PROPOSED HIGHWAY PROJECT

JUNEAU-RIVERSIDE AND STEPHEN RICHARDS CONGESTION MITIGATION PROJECT NO. 0003207/SFHWHY00081

GRADING, PAVING, SIDEWALKS, SIGNING, STRIPING, ILLUMINATION & SIGNALIZATION

TYPE IA JUNCTION BOX

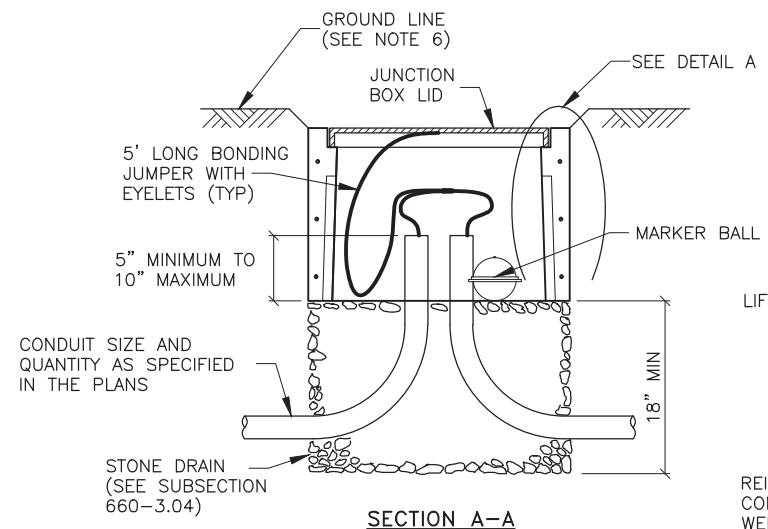
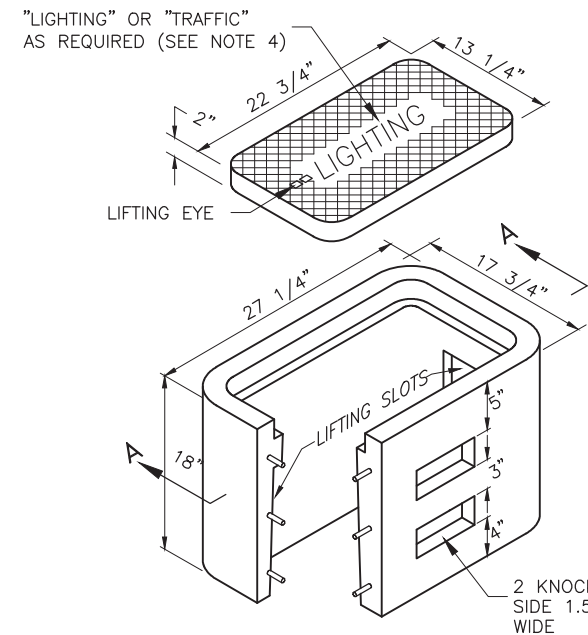
Change Order #1 allows minimum weight of 200 lbs.

Detail A is modified to that from L-23.01 by Change Order #1.
